**PLANNING COMMISSION
Meeting Agenda
Monday – June 28, 2010
7:00 PM - Regular Meeting
City Council Chambers – 155 NW 2nd Avenue**

PLANNING COMMISSION PUBLIC HEARING STAFF REPORT

Site and Design Review (DR 10-01)

PROFESSIONAL OFFICE BUILDING
 DCS-MORGAN

Site Plan

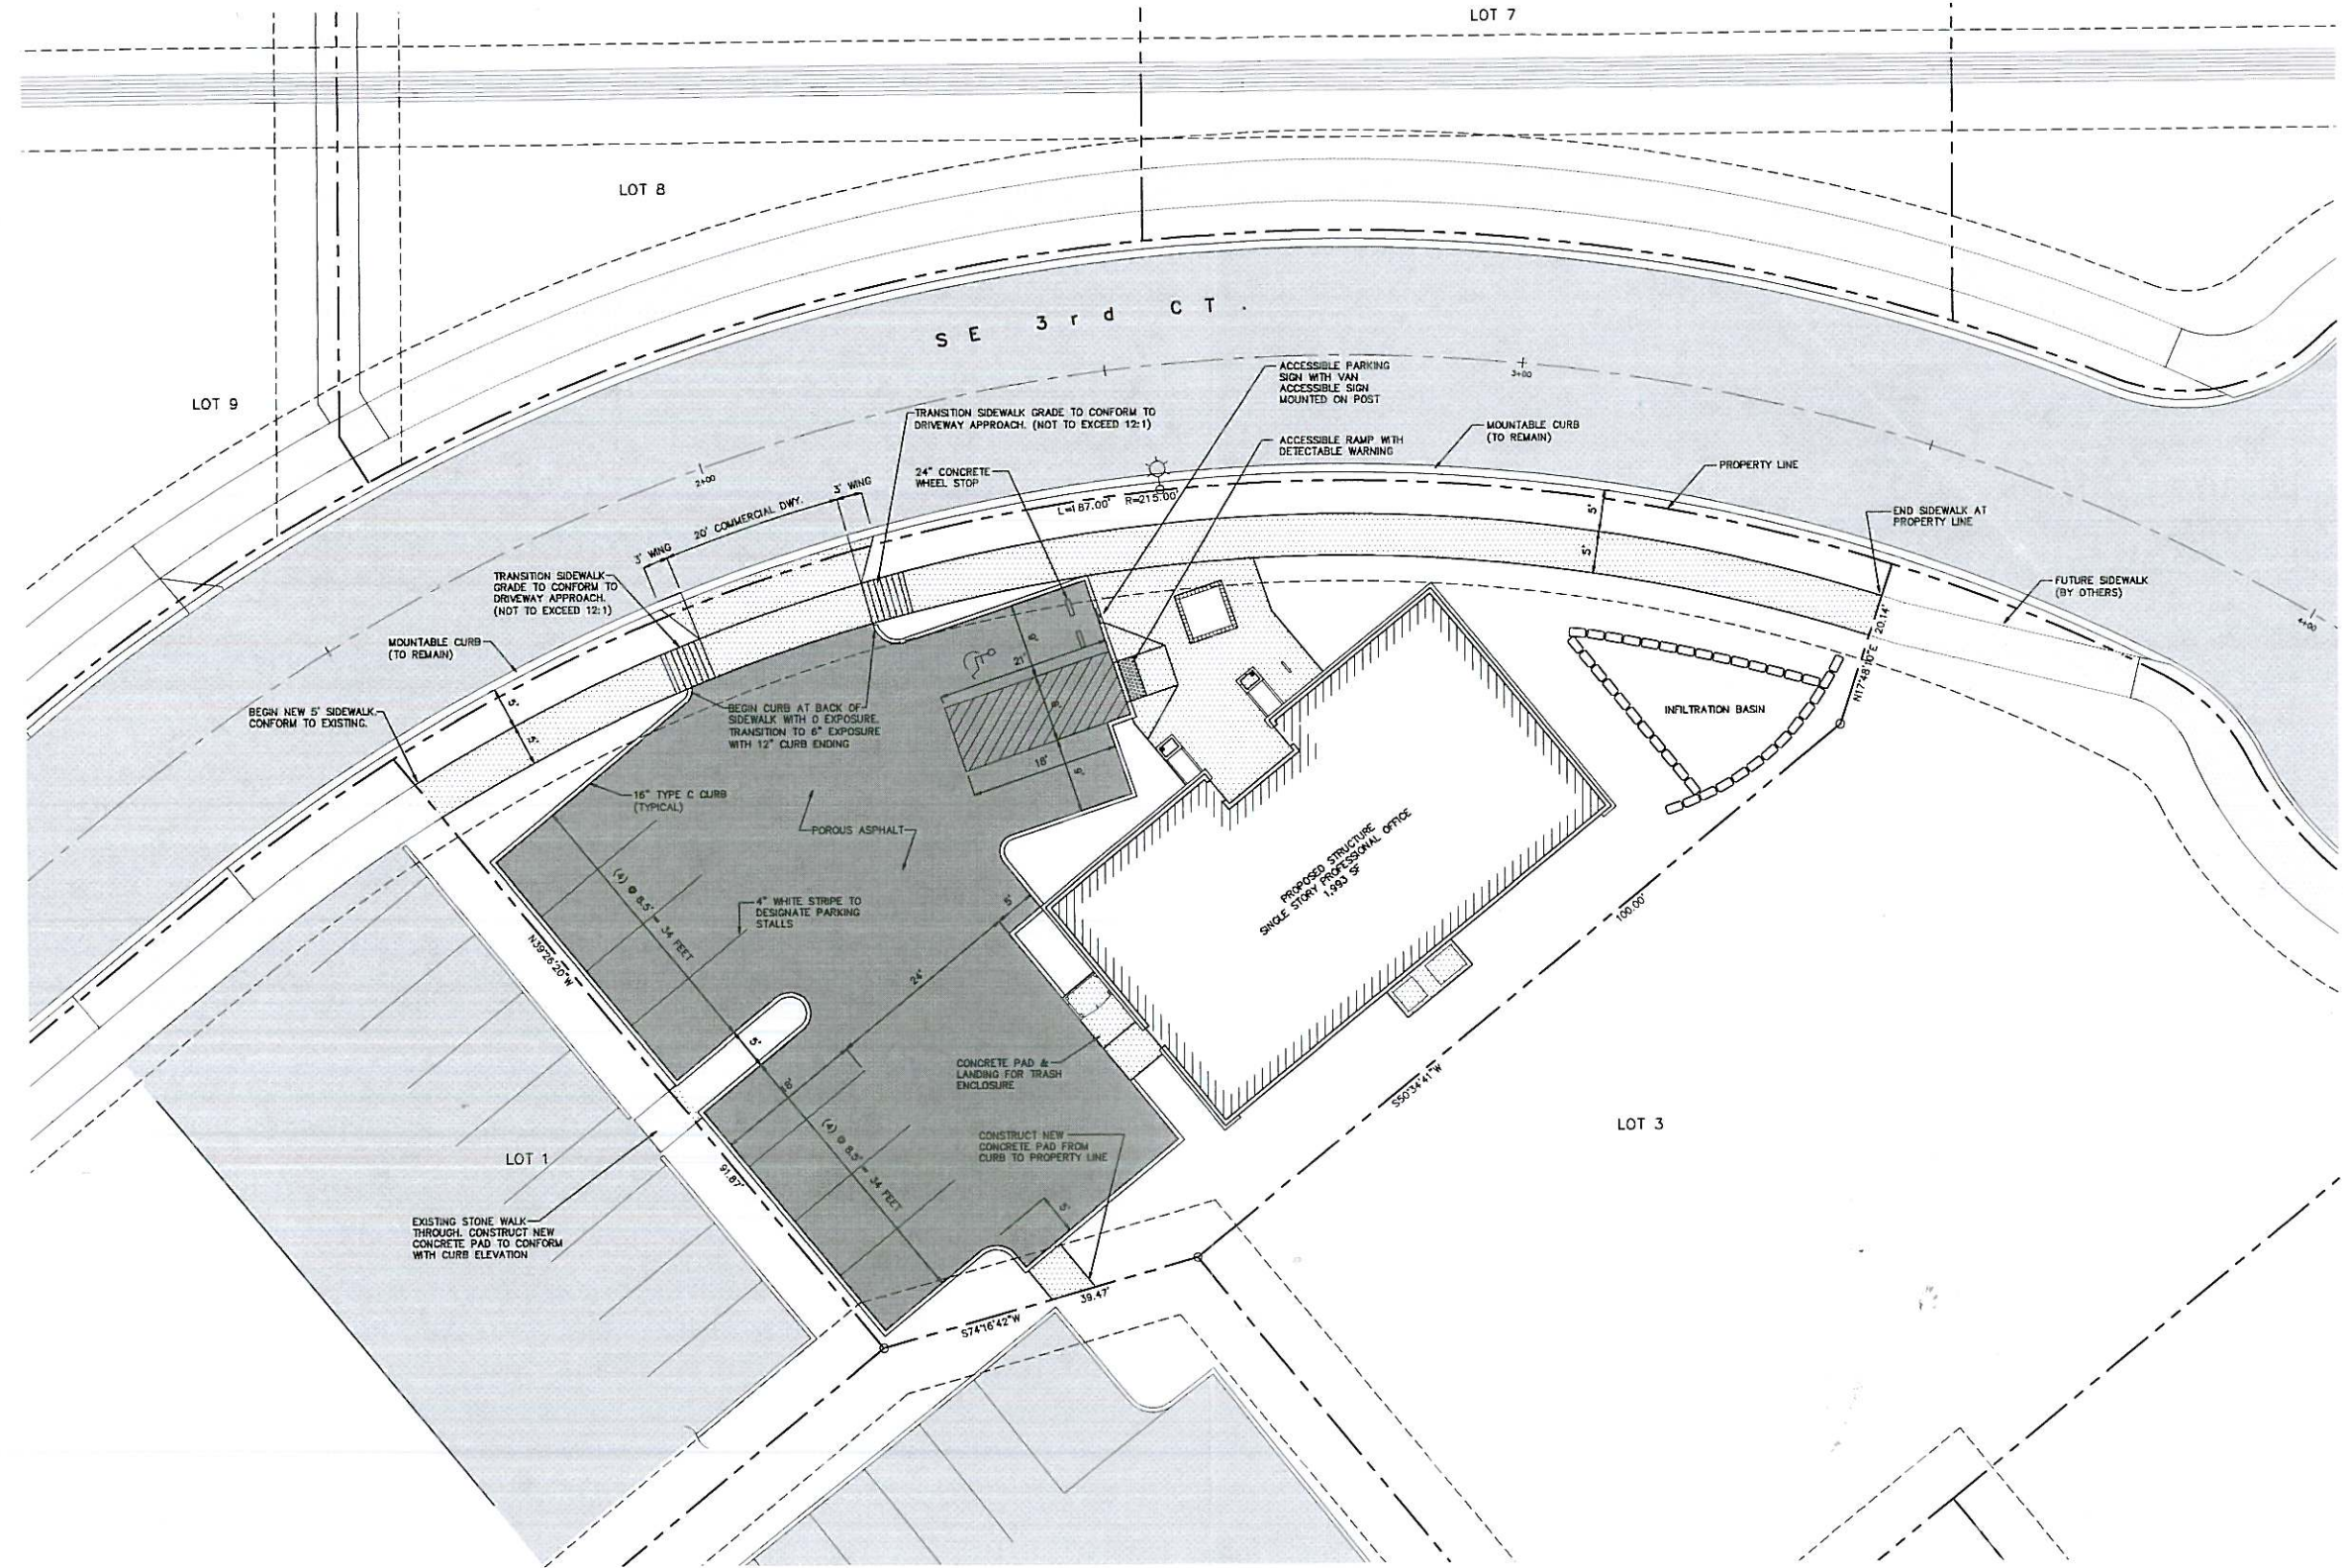
- Site Plan. The overall design appears pleasing, functional, and an efficient use of the property. Except for one somewhat awkward parking space at the far northwest corner of the site in terms of backing out without blocking the entrance drive, the site should function well and offer a very pleasing landscape. The criterion for A above is met.

Canby Public Works: Requested plans showing sanitary sewer lateral, as a conflict with the location of proposed trees too close to the line and cleanout appears to exist. Planning staff has added a condition of approval to address this issue. He was concerned that another tree may partially block the existing street light. Planning staff notes that the mature diameter of the tree as shown along with the slow growth rate and moderate size of the tree species chosen should outweigh the need to eliminate this desirable street tree location. Planning secured supplemental site development plans that confirm that the storm water overflow line is proposed to be utilized. Public works staff highly recommended not using cattails in the detention pond as they tend to contribute to plugging of the overflow piping.

1. Eliminate or satisfactorily relocate the Nyssa Sylvatica tree proposed at the northwest corner of the site so as not to conflict with the sanitary sewer lateral and cleanout maintained by the City through a note on the final contract landscape plan.

Underground Utilities Plan

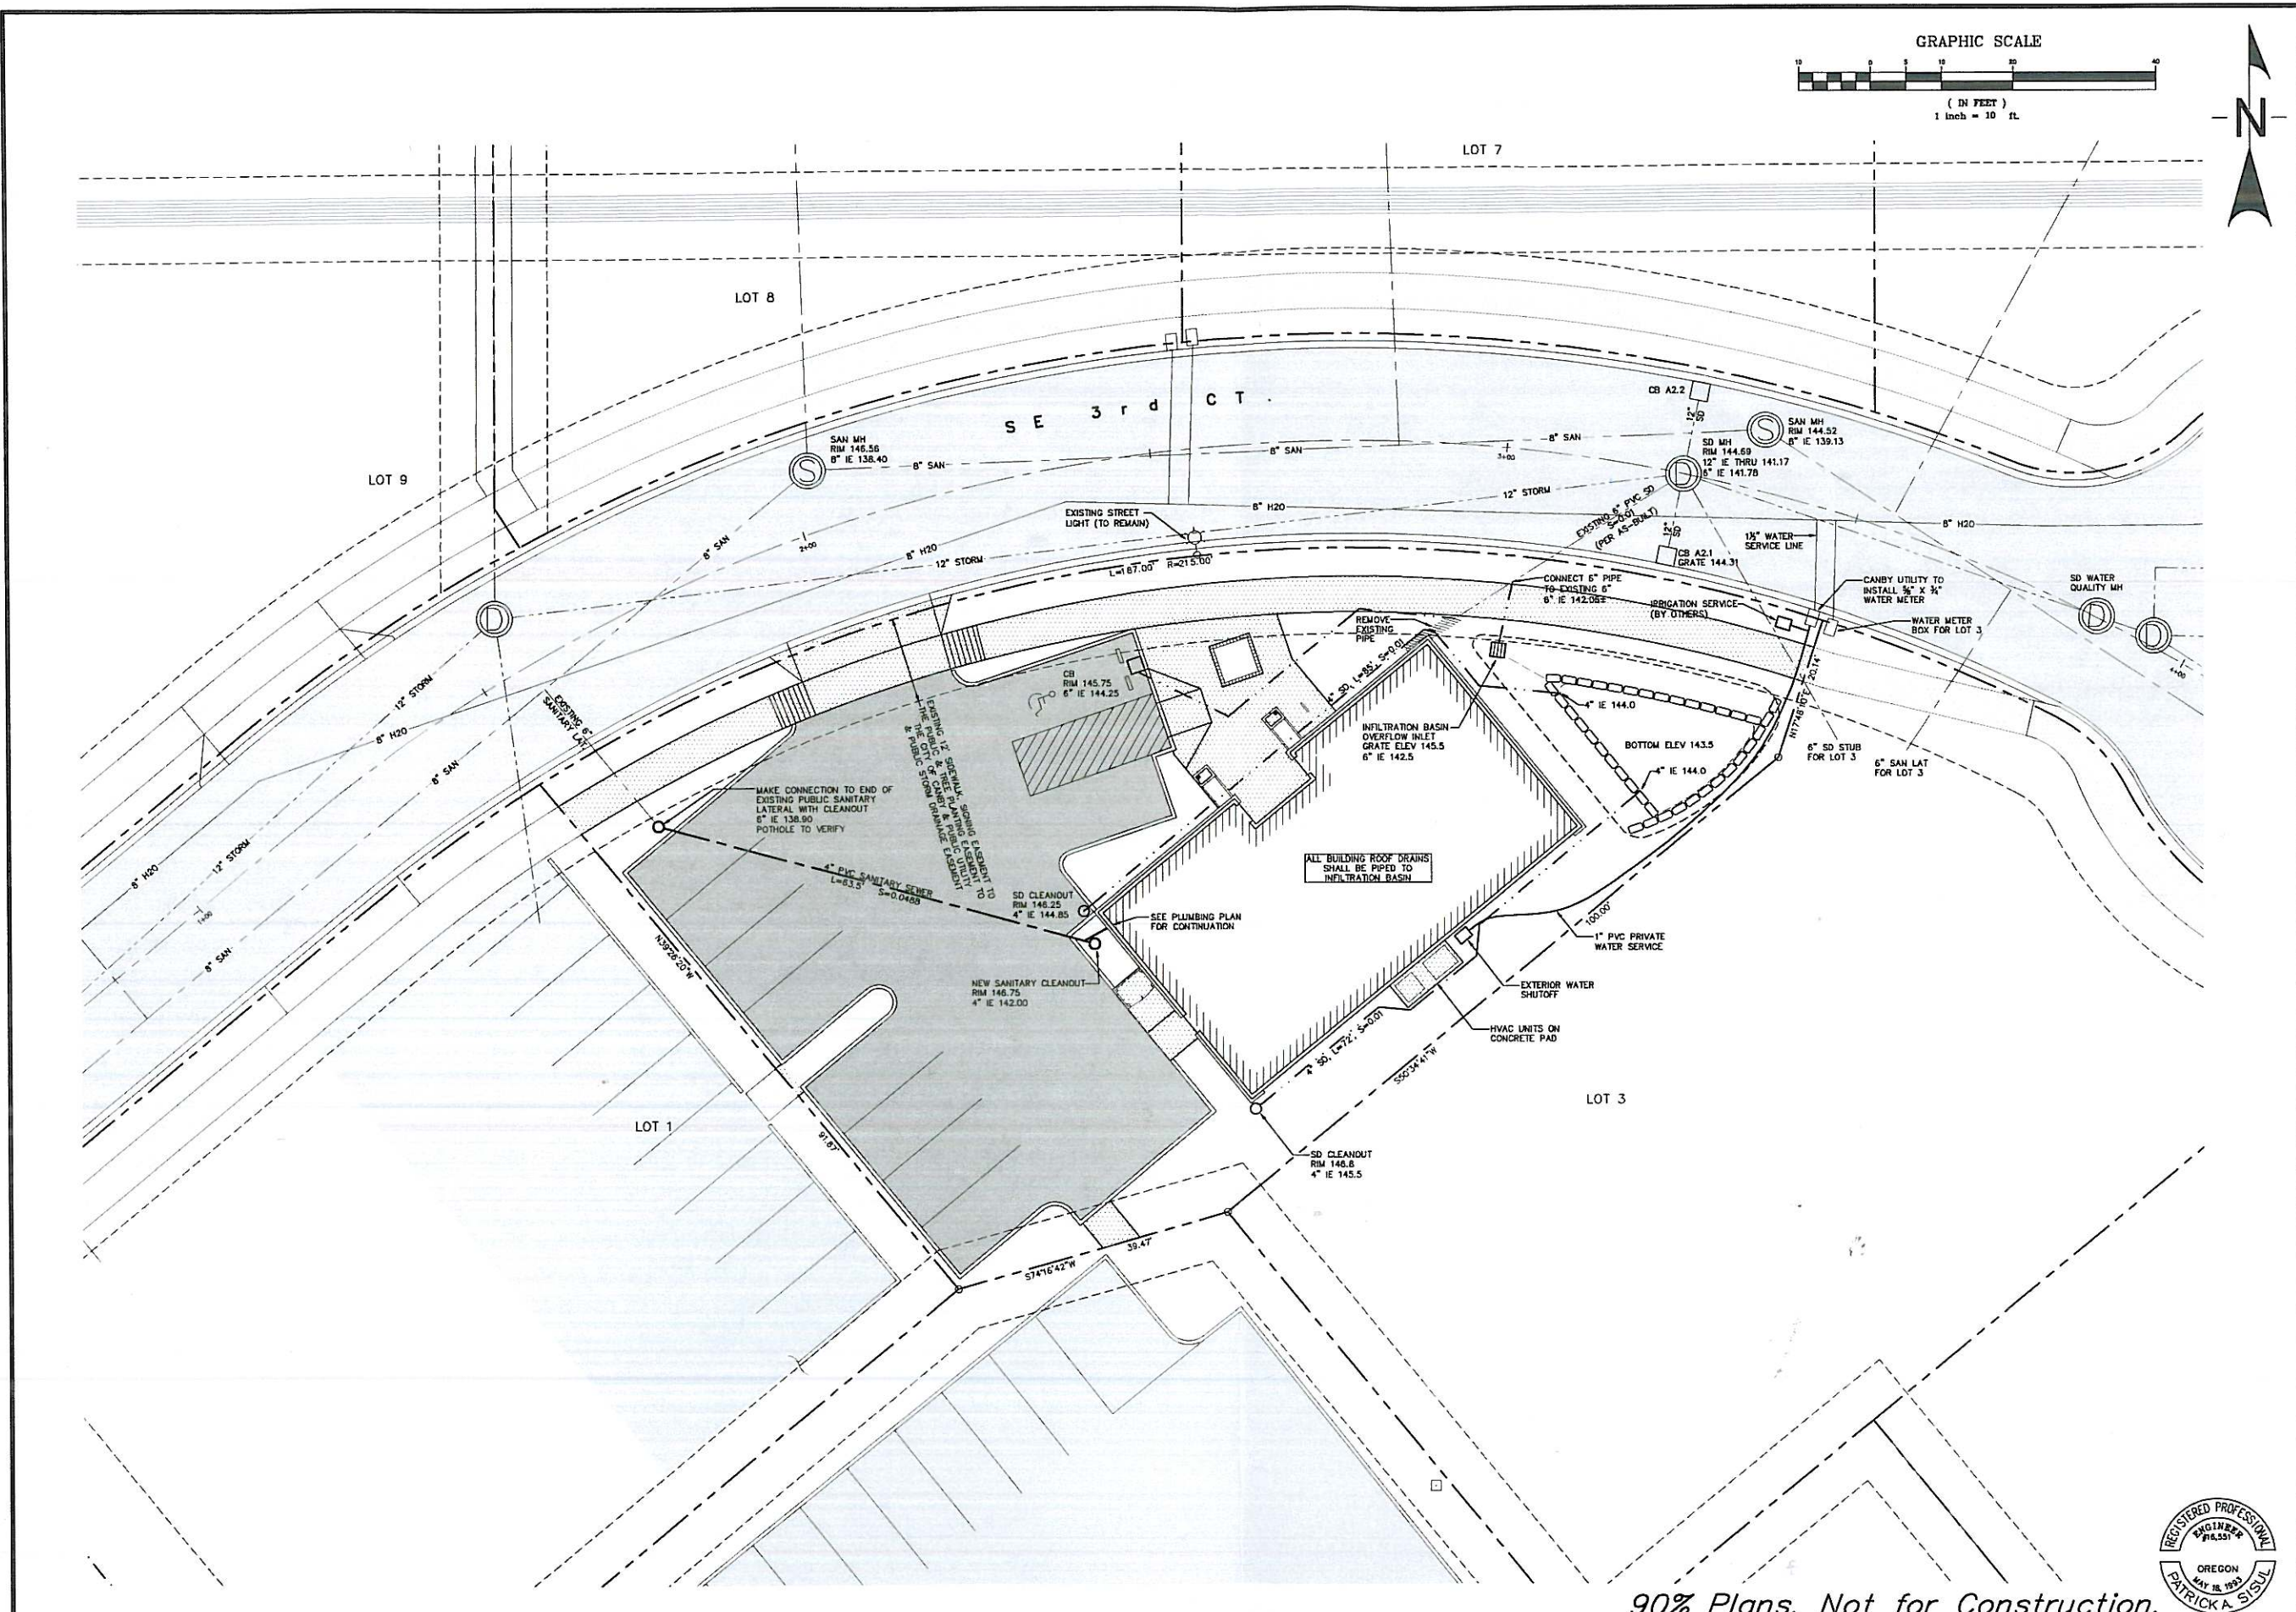
- **Adequate Public Facilities.** It must be demonstrated that all required public facilities and services are available, or will become available through the development, to adequately meet the needs of the proposed development. Sheet C2 of the supplemental 90% Plan submittal

clearly indicates the location of Sanitary Sewer, Water, and Storm systems within the private street right-of-way. The pre-application conference meeting summary indicates that electric, and telephone services are readily available and can be accommodated. (see attached pre-application conference summary).
